Date of Issue: March 31, 2017

Affected Publication: API Specification 6D, Specification for Pipeline and Piping Valves, Twenty-fourth Edition, August 2014

ERRATA 9

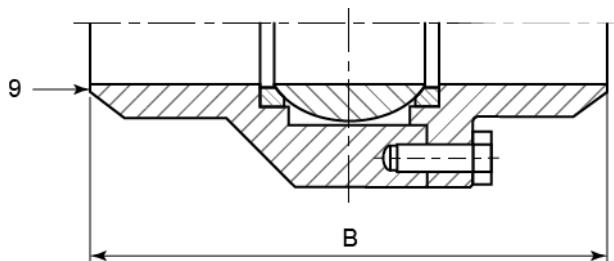
Page 35, **Section 11**, delete the text in the red box:

On valves whose size or shape limits the body markings, they may be omitted in the following order:

- 1) size,
- 2) rating,
- 3) material,
- 4) manufacturer name or trademark.

Figure B.8—Full-opening Swing Check Valve

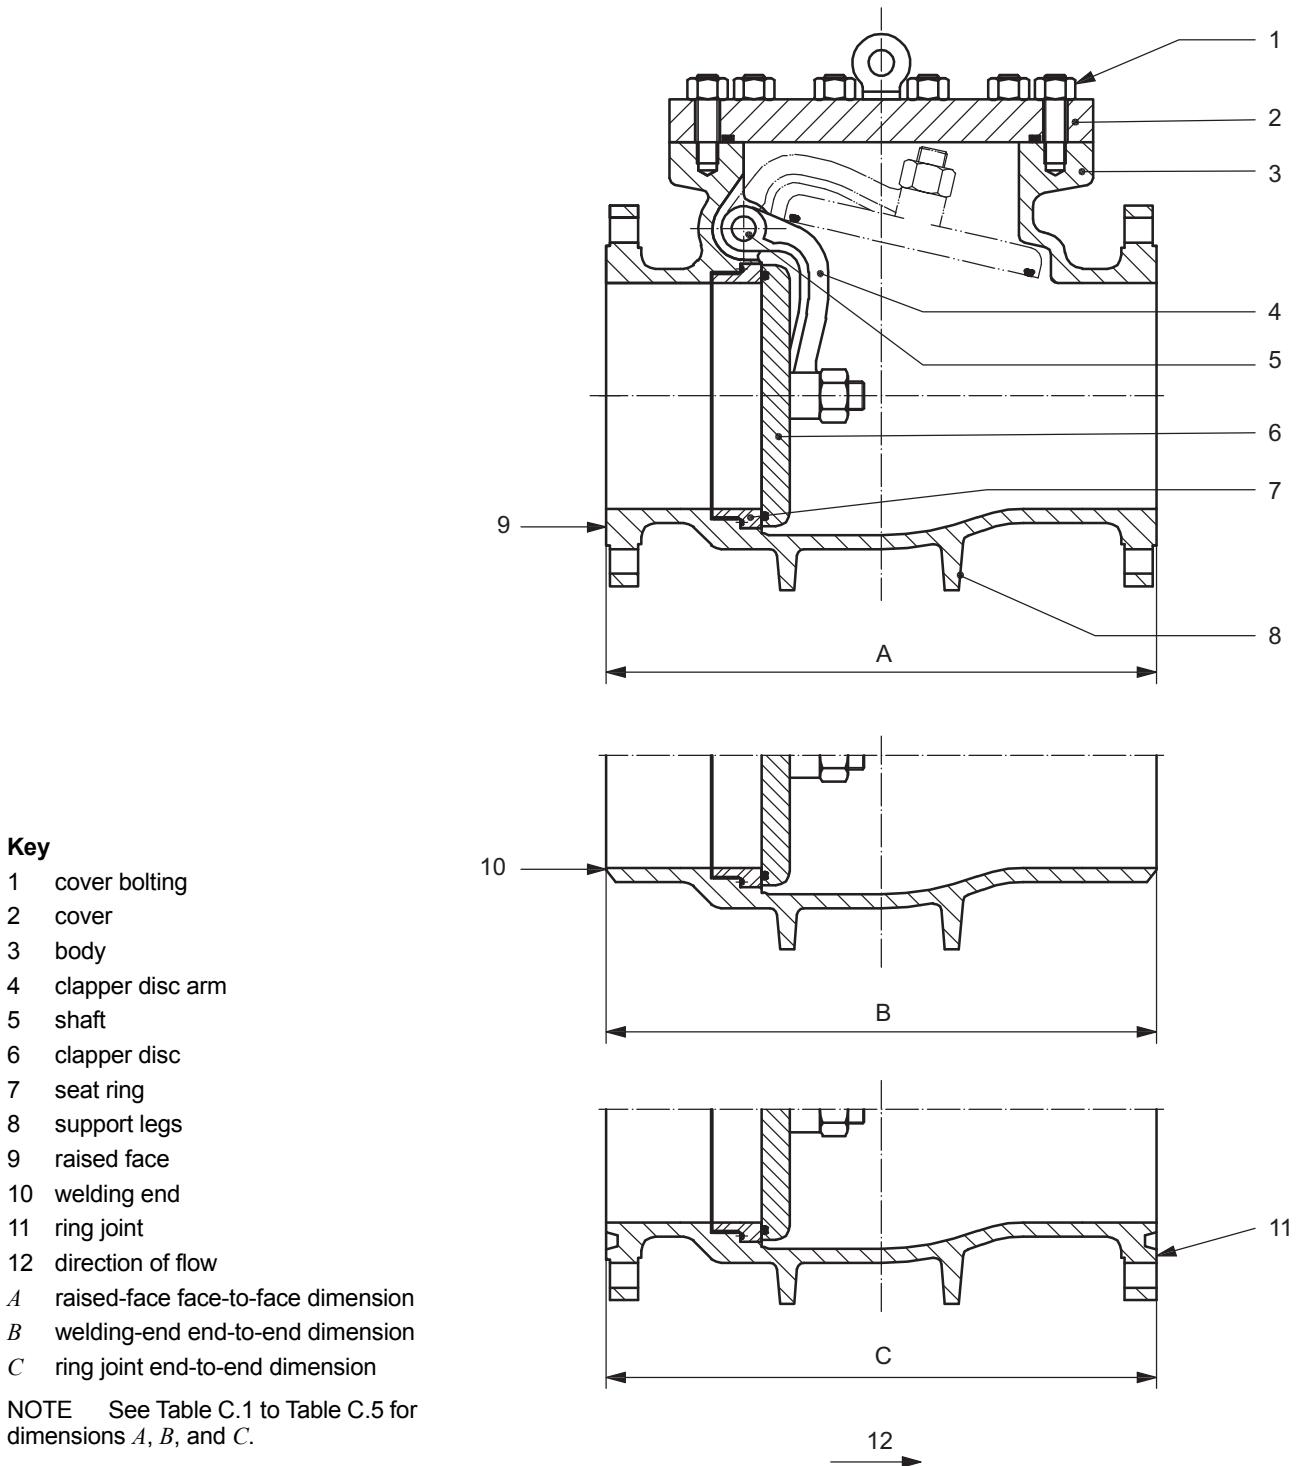
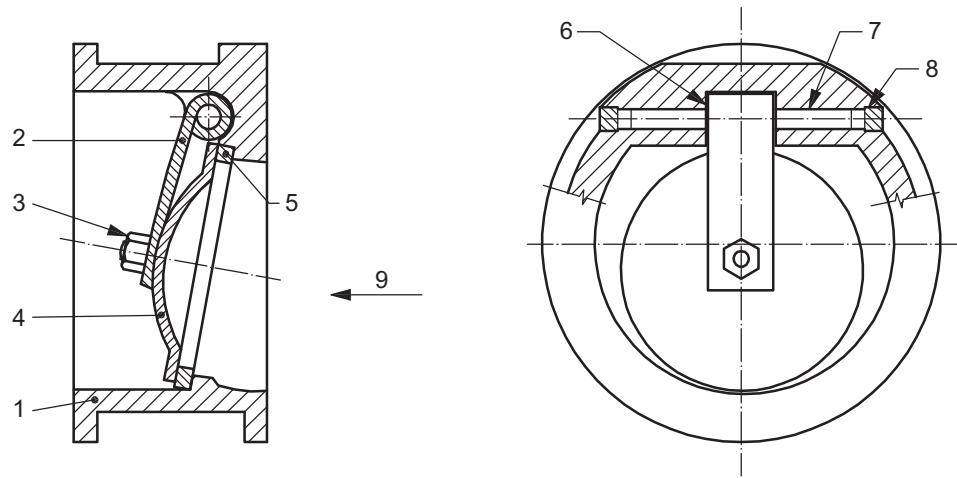
Page 51, **Figure B.8**, in the **Key**, revise 6) and 7) as follows:

- 6) clapper disc
- 7) seat ring

Figure B.14—Floating Ball Valve

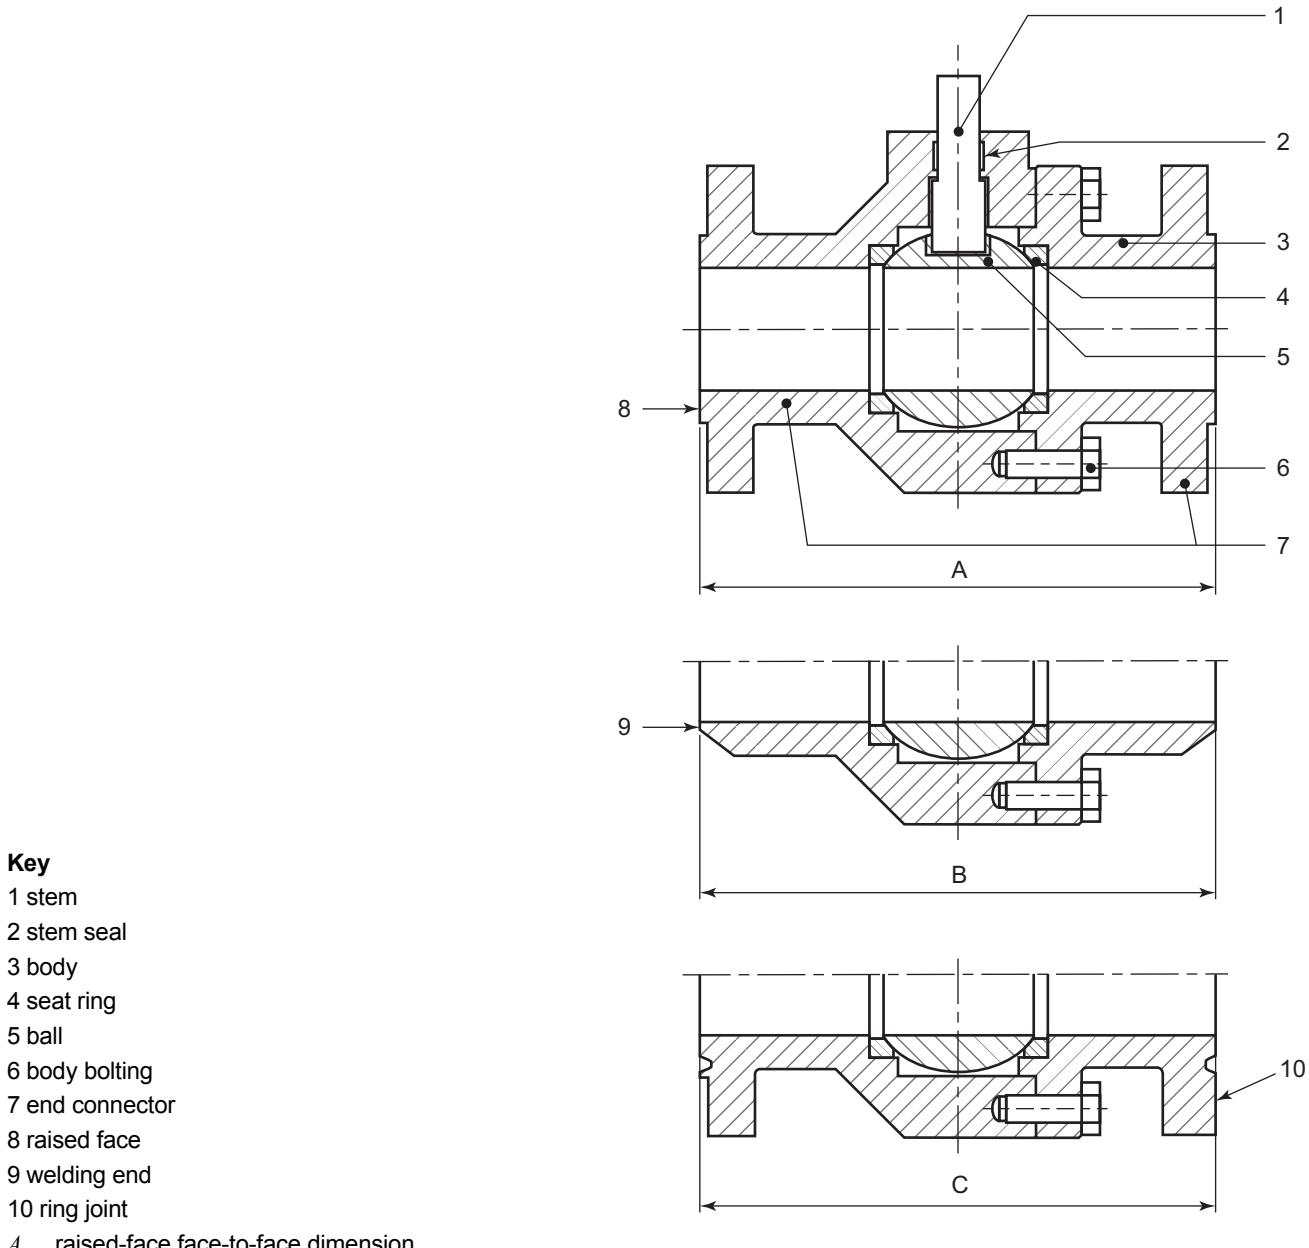
Page 57, **Figure B.14**, replace part B of the figure as follows:

Figure F.2—Thermocouple Locations—Cylindrical Furnace (Working Zone)

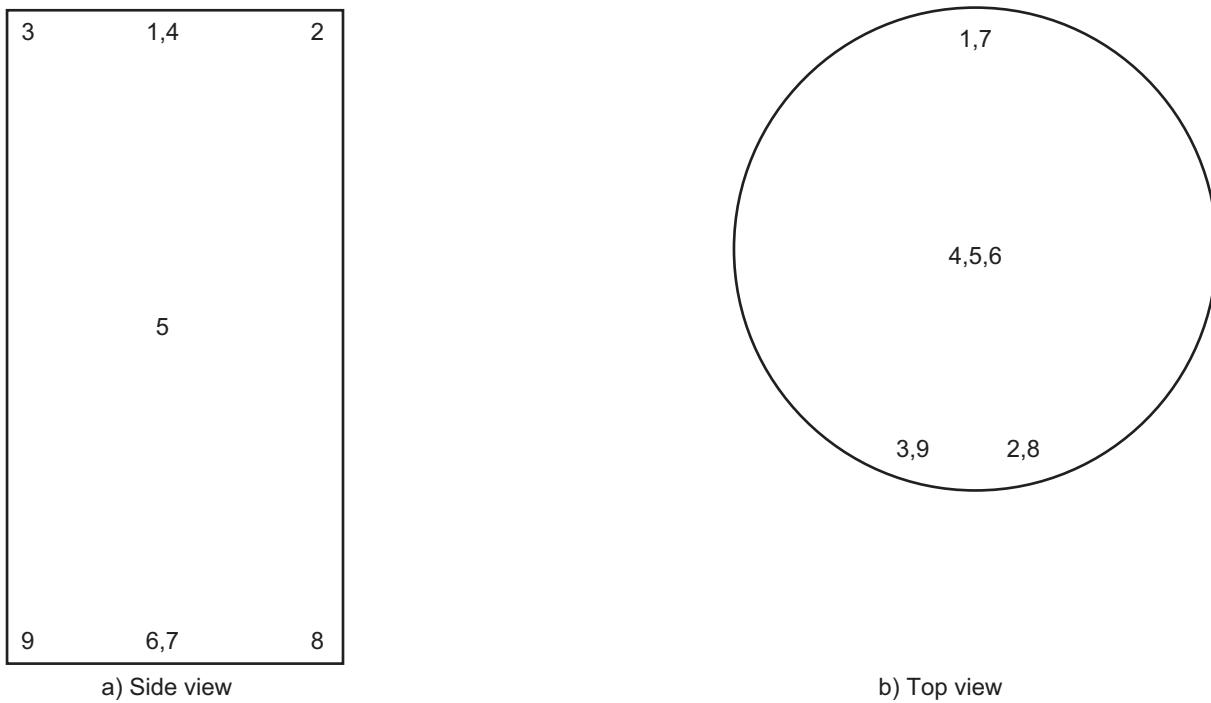
Page 81, Figure F.2, replace the labels on the figures to read:

Figure K.6—Double Isolation and Bleed—Type B

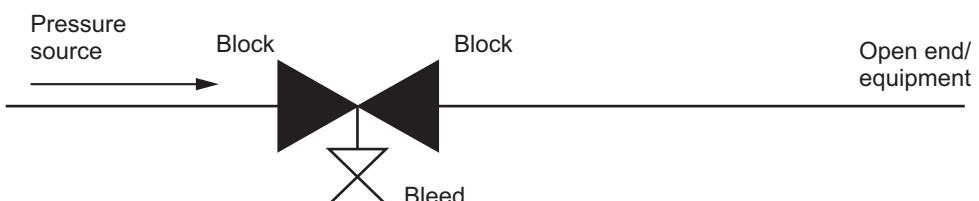
Page 100, Figure K.6, replace the figure as follows:
